V2500 Propulsion System - Nacelle **SERVICE BULLETIN**

NACELLE - EXHAUST - ACTUATOR, THRUST REVERSER, - REPLACEMENT OF

V2500-NAC-78-0173

Introduction of an Actuator with Improved Piston Rod Sealing.

Post Mod L1801-04
Figure 2

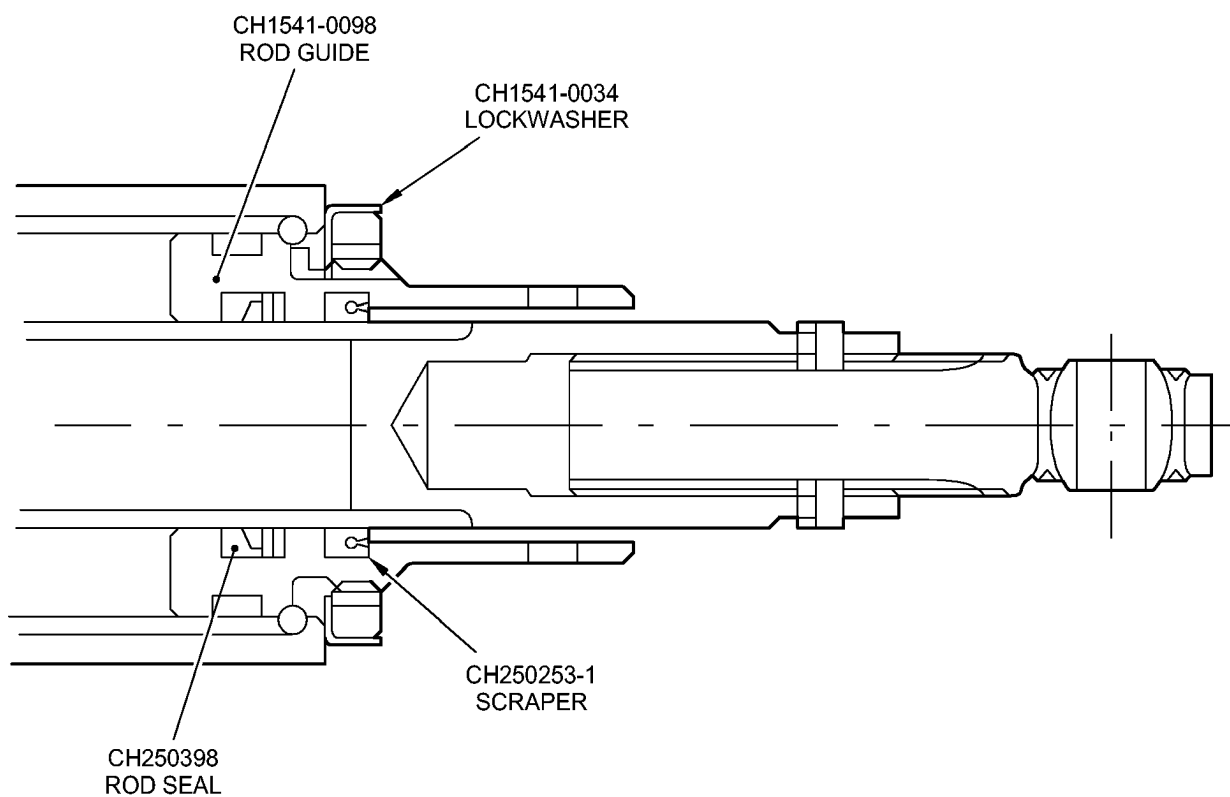
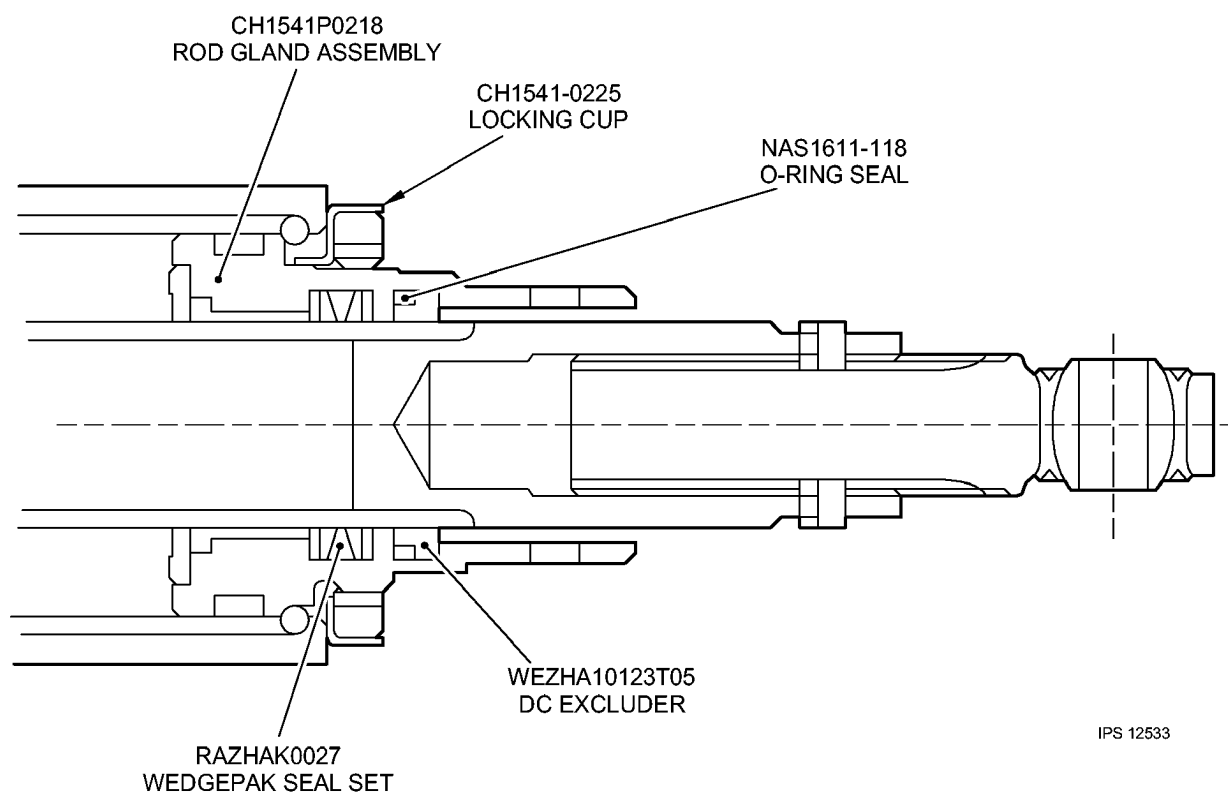
The List of Components and Figure 2 amended, part marking information added, CSC contact numbers updated and several minor changes introduced.

Cases have occurred where actuators have exhibited reduced reliability due to excessive external leaks from the piston rod seal. This modification introduces an improved piston rod/piston rod guide interface.

(1) This Service Bulletin (SB) introduces a new rod gland and a new piston assembly. The new piston assembly has a chrome plated and superfinished piston rod. The rod gland is modified to provide additional piston rod support and improved internal sealing.

Pre Mod L1801-04
Figure 1

Rod Seal and Scraper
Figure 3

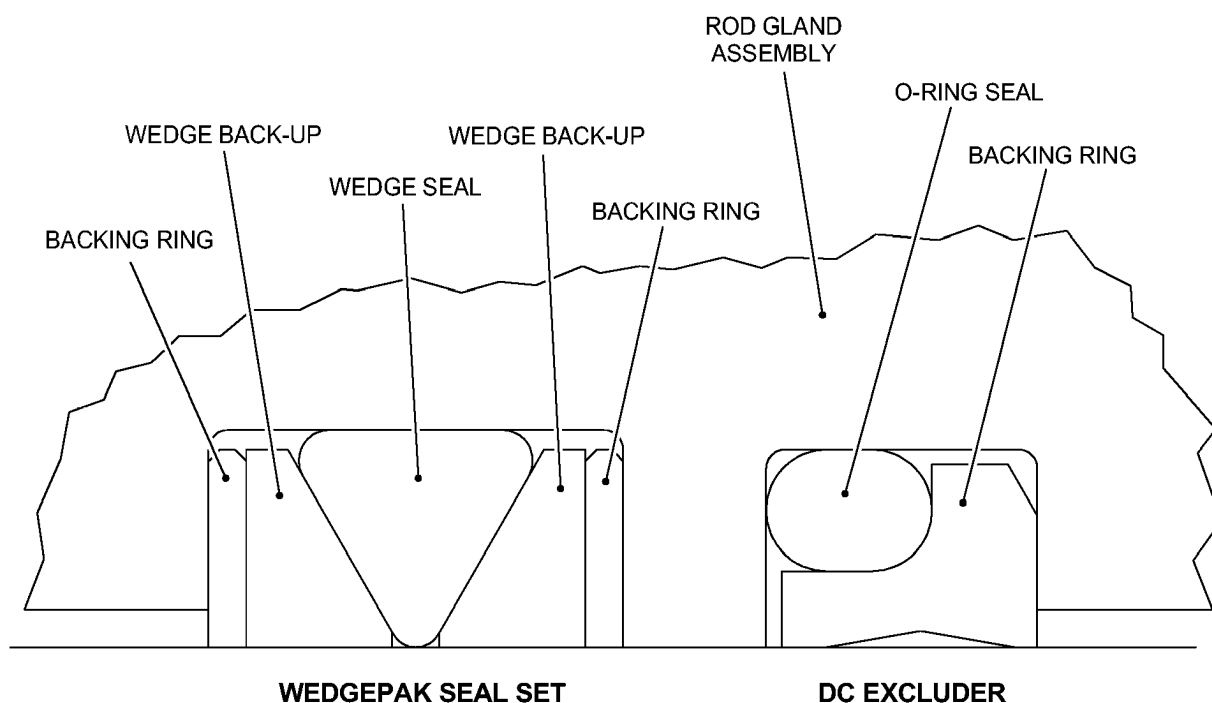
- (5) Ignore para 5H (Ref ASSEMBLY) and install the rod gland assembly as follows (Ref Fig 2, 3 and 4, and Ref CMM 78-31-13 Fig 302):
- (a) With the Seal Assembly Tool CHA1542-0037, install the piston seal (340, Fig 302) on the rod gland assembly (CH1541P0218).

- (b) Lubricate the wedgopak seal set (RAZHAK0027) components with Skylube fluid.
 - (c) Insert the first backing ring in rod gland assembly (CH1541P0218).

- (d) Insert the first wedge backing in the rod gland assembly.
 - (e) With the Setting Plug A673856, insert the wedge seal in the rod gland assembly.
 - (f) Insert the second wedge backing in the rod gland assembly.

- (g) Insert the second backing ring the rod gland assembly.
 - (h) Visually examine the rod seal components to make sure they are in correct position.

- (j) Lubricate the DC excluder (WEZHA10123T05) components with Skylube fluid.
 - (k) Install the DC Excluder O-ring seal (NAS 1611-118) in the rod gland assembly (CH1541P0218) followed by the backing ring, making sure that the O-ring seal is engaged on the backing ring.

Location of Rod Gland Assembly in Jack Head Assembly
Figure 4

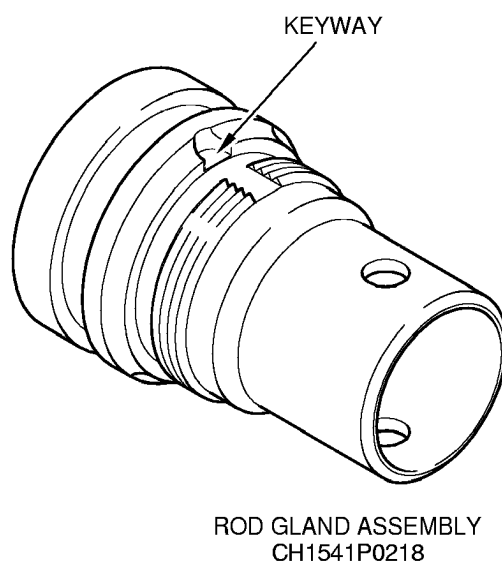
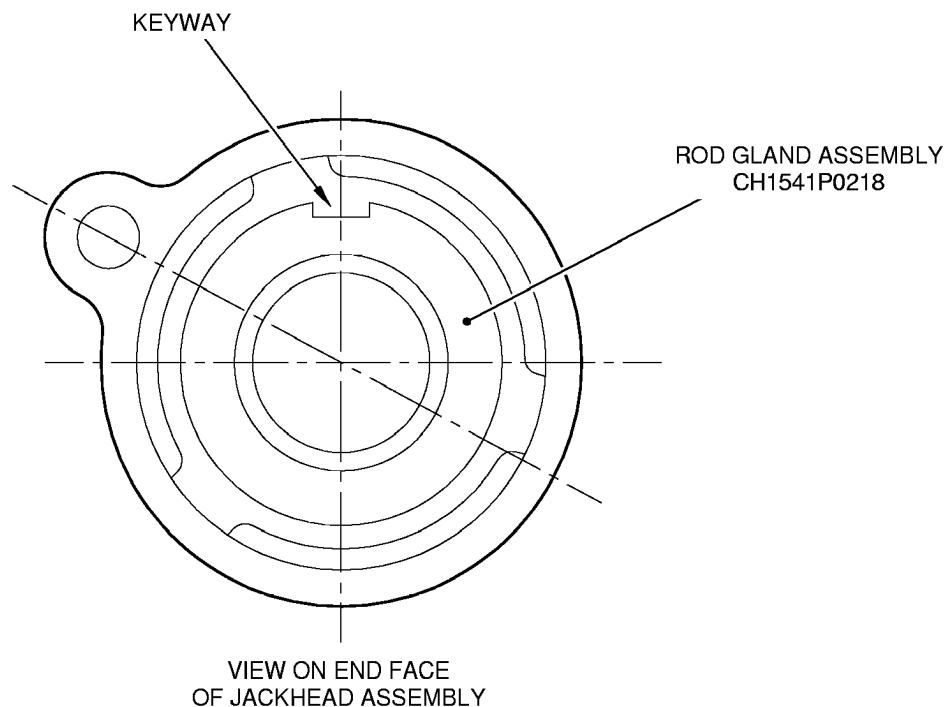
CAUTION: INSTALL THE ROD GLAND ASSEMBLY IN THE JACK HEAD ASSEMBLY WITH THE KEY SLOT UPPERMOST (REF FIG 4).

- (r) Install the rod gland assembly (CH1541P0218) in the jack head assembly with the key slot uppermost (Ref Fig 4) and position rod gland sufficient to let the retaining ring (320, Fig 302) be installed.
- (s) Install the retaining ring (320, Fig 302), with the segments equally spaced, in the jack head assembly and pull the rod gland assembly (CH1541P0218) against the retaining ring.
- (t) Install the locking cup (CH1541-0225) WA- and the nut (300, Fig 302) WA- on the rod gland assembly (CH1541P0218).
- (u) Hold the rod gland assembly (CH1541P0218) with the holding tool CHA1542-0055. With the Dog Spanner CH1542-0054, torque tighten the nut 73,17 to 89,43Nm (54 to 66 lbf ft).
- (v) Remove the Guide CHA1542-0058 from the piston brazing assembly.

Unit Nameplate and Amendment Section
Figure 5

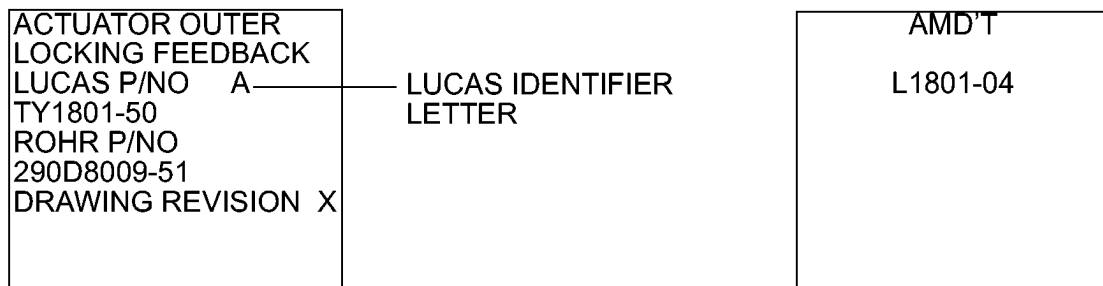
- (1) Use the electro-chemical etch method or ink and varnish to re-identify the TY1801-03 unit (Ref Fig 5).

TY1801-03 Lucas ident letter C Re-identified as TY1801-50 Lucas ident letter A

Post Mod L1802-08
Figure 2

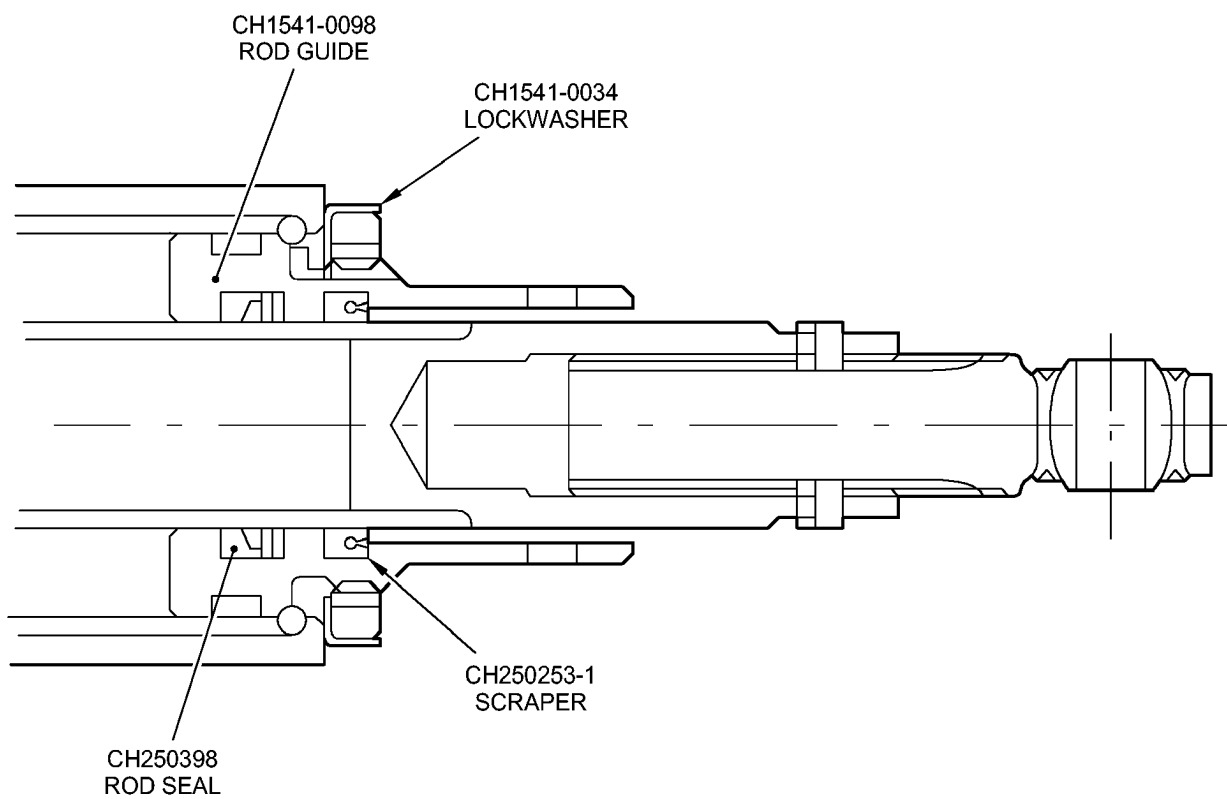
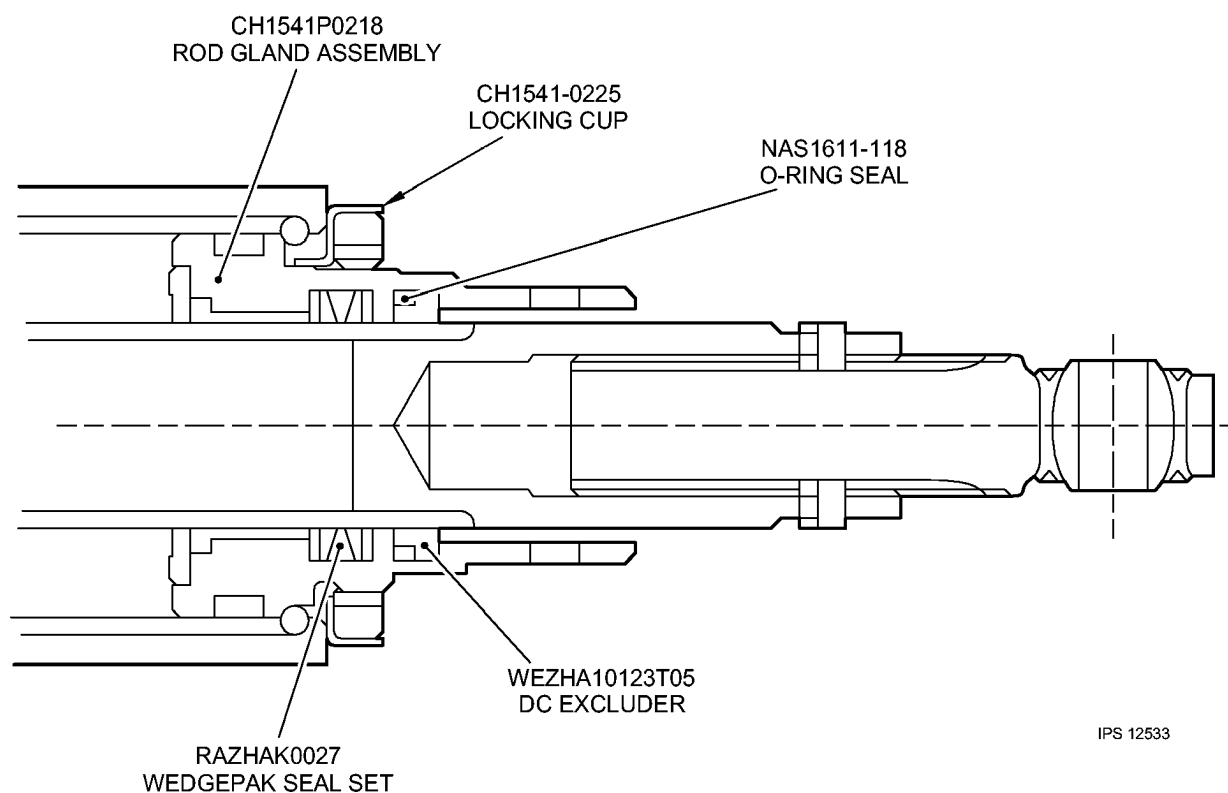
The List of Components and Figure 2 amended, part marking information added, CSC contact numbers updated and several minor changes introduced.

Cases have occurred where actuators have exhibited reduced reliability due to excessive external leaks from the piston rod seal. This modification introduces an improved piston rod/piston rod guide interface.

This Service Bulletin (SB) introduces a new rod gland and a new piston assembly. The new piston assembly has a chrome plated and superfinished piston rod. The rod gland is modified to provide additional piston rod support and improved internal sealing.

Post Mod Rod Seal and Scraper
Figure 3

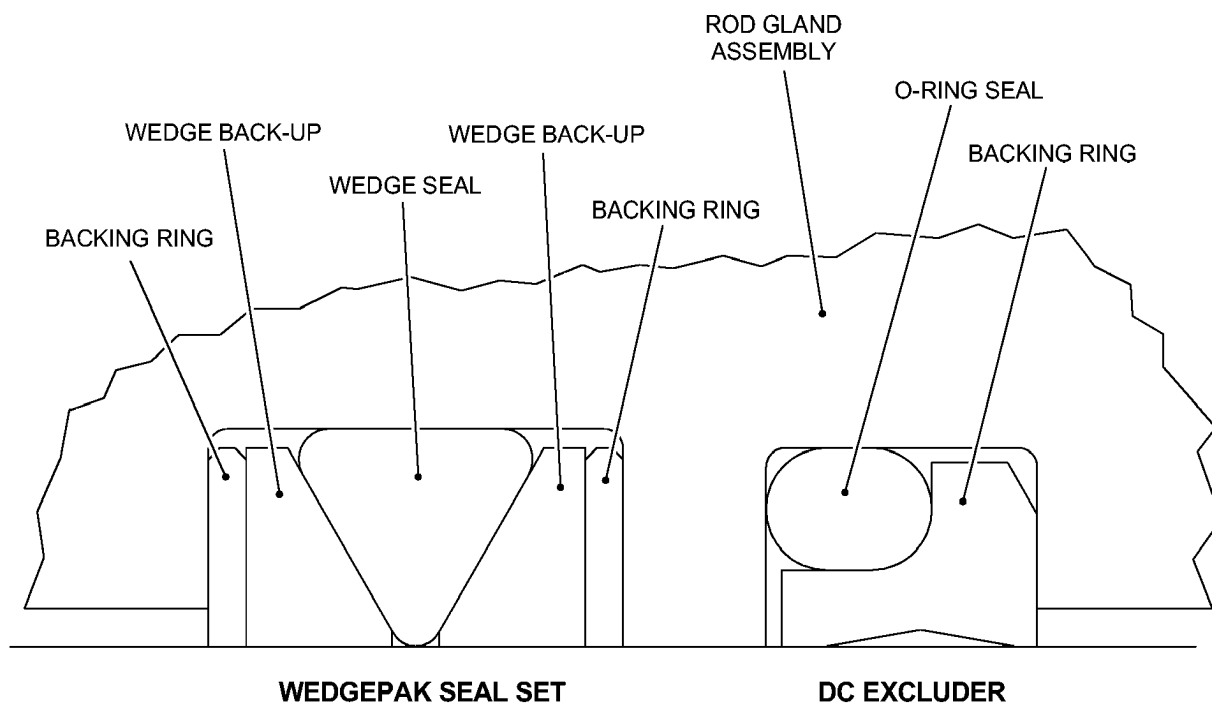
(j) Lubricate the DC excluder (WEZHA10123T05) components with Skylube fluid.

(k) Install the DC Excluder O-ring seal in the rod gland assembly (CH1541P0218)
followed by the backing ring, making sure that the O-ring seal is engaged on the
backing ring.

Location of Rod Gland Assembly in Jack Head Assembly
Figure 4

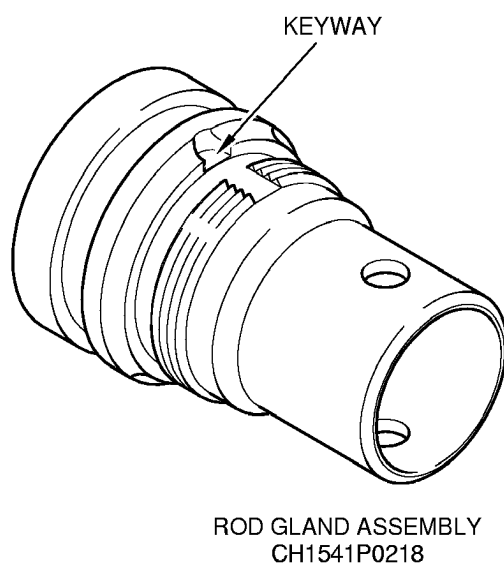
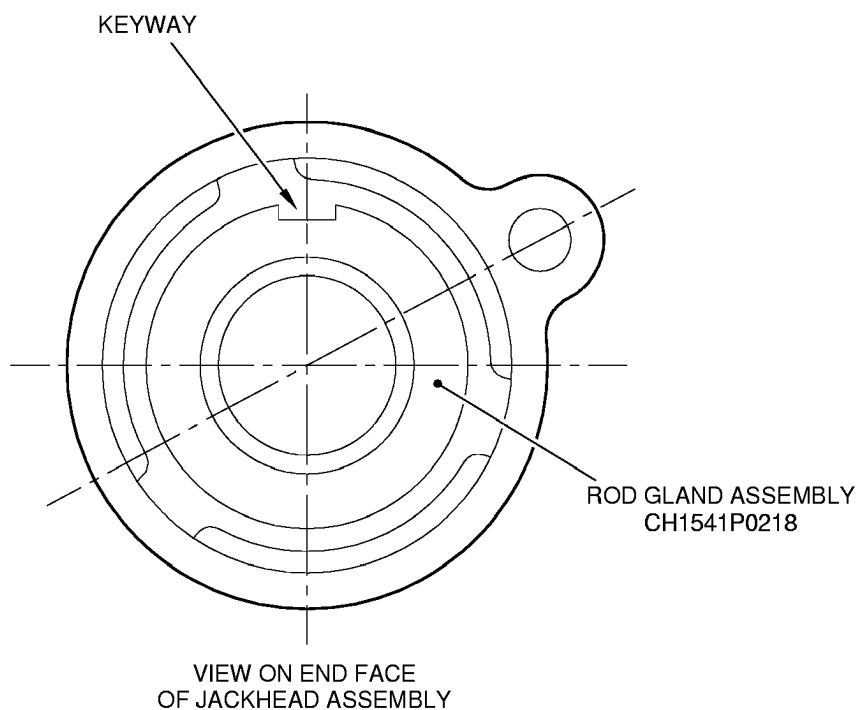
- (q) Immediately remove the Settling Block and the Settling Plug from the rod gland assembly (CH1541P0218). Quickly clean the rod gland assembly in Phosphate Ester Base Type 4 to remove the ice particles.

Unit Nameplate and Amendment Section
Figure 5

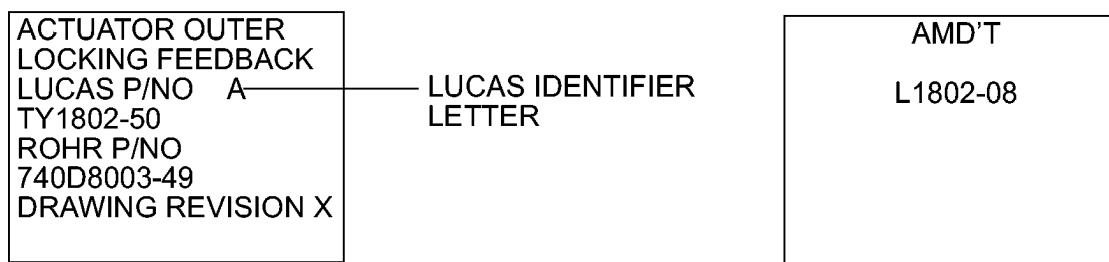
- (1) Use the electro-chemical etch method or ink and varnish to re-identify the TY1802-04 unit (Ref Fig 5).

TY1802-04 Lucas ident letter C Re-identified as TY1802-50 Lucas ident letter A
